Nomination Form
Anadromous Waters Catalog

Region Interior USGS Quad(s) HEALY D-5
 Anadromous Waters Catalog Number of Water Body 334-40-11000-2490-3200 (-4079)
 Name of Water Body Nenana River, unnamed tributary USGS Name Local Name
 Addition Deletion Correction Backup Information

Nomination #	<u>25-687</u>	<u>[Signature]</u>	<u>10/25/2025</u>
		Fisheries Scientist	Date
Revision Year:	<u>2026</u>	<u>[Signature]</u>	<u>10/24/25</u>
		Habitat Operations Manager	Date
Revision to:	<input checked="" type="checkbox"/> Atlas <input checked="" type="checkbox"/> Catalog	<u>[Signature]</u>	<u>26 Sept 2025</u>
		AWC Project Biologist	Date
Revision Code:	<u>C-9, F-1</u>	<u>[Signature]</u>	<u>10/29/2025</u>
		GIS Analyst	Date

Map #3

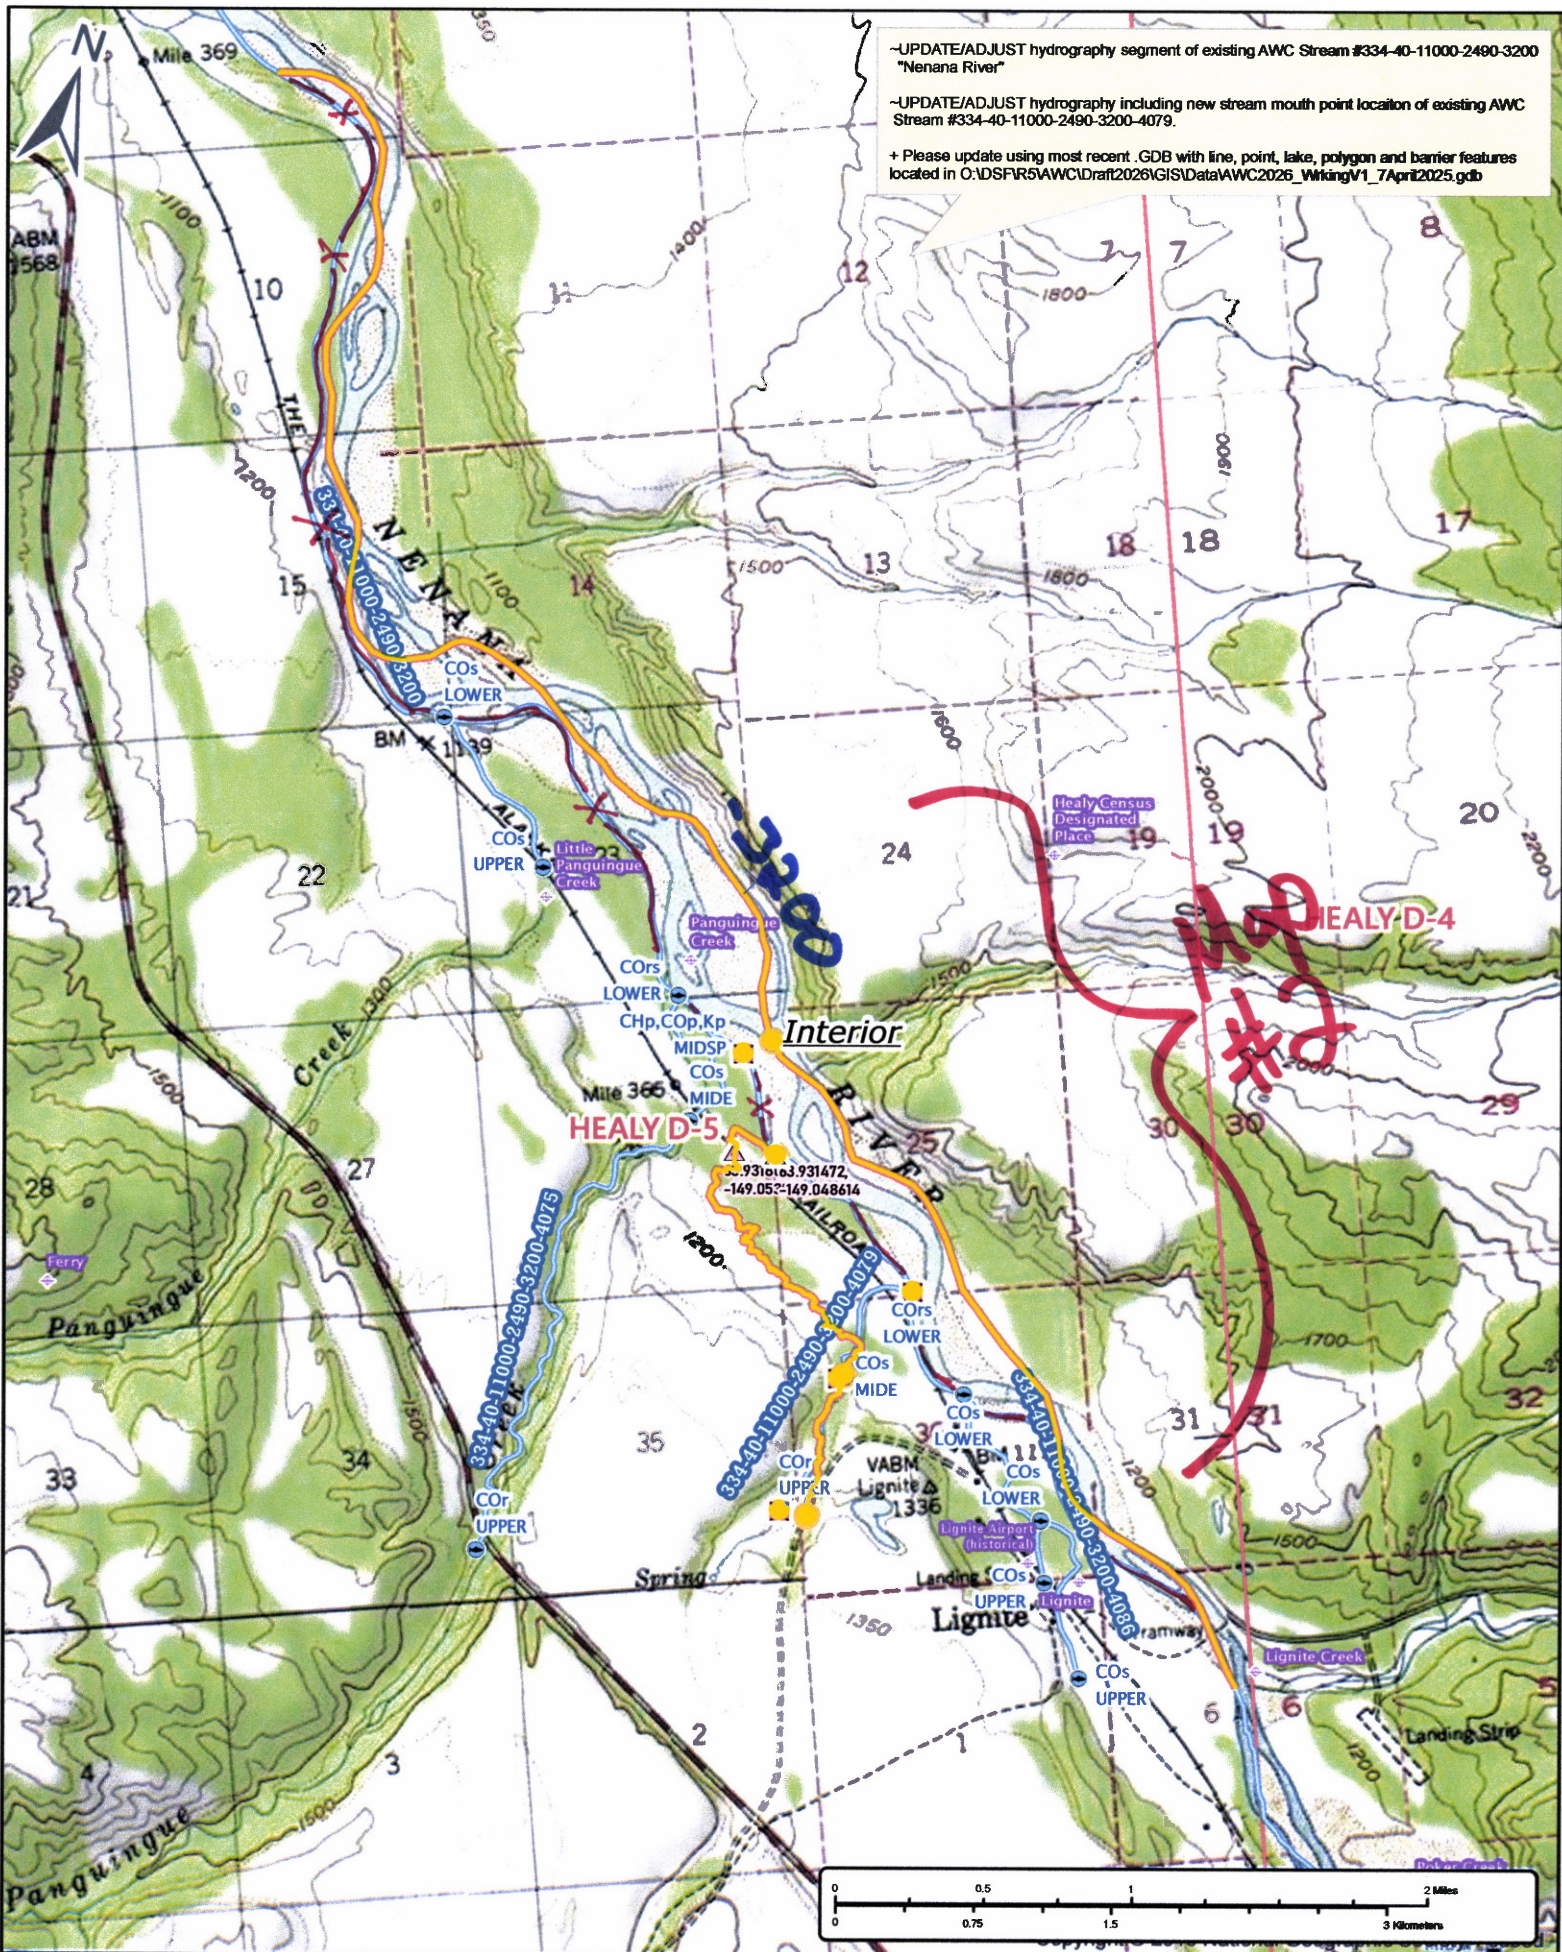
-UPDATE/ADJUST hydrography segment of existing AWC Stream #334-40-11000-2490-3200 "Nenana River"

-UPDATE/ADJUST hydrography including new stream mouth point location of existing AWC Stream #334-40-11000-2490-3200-4079.

+ Please update using most recent .GDB with line, point, lake, polygon and barrier features located in O:\DS\FR5\AWC\Draft2026\GISData\AWC2026_VrkingV1_7April2025.gdb
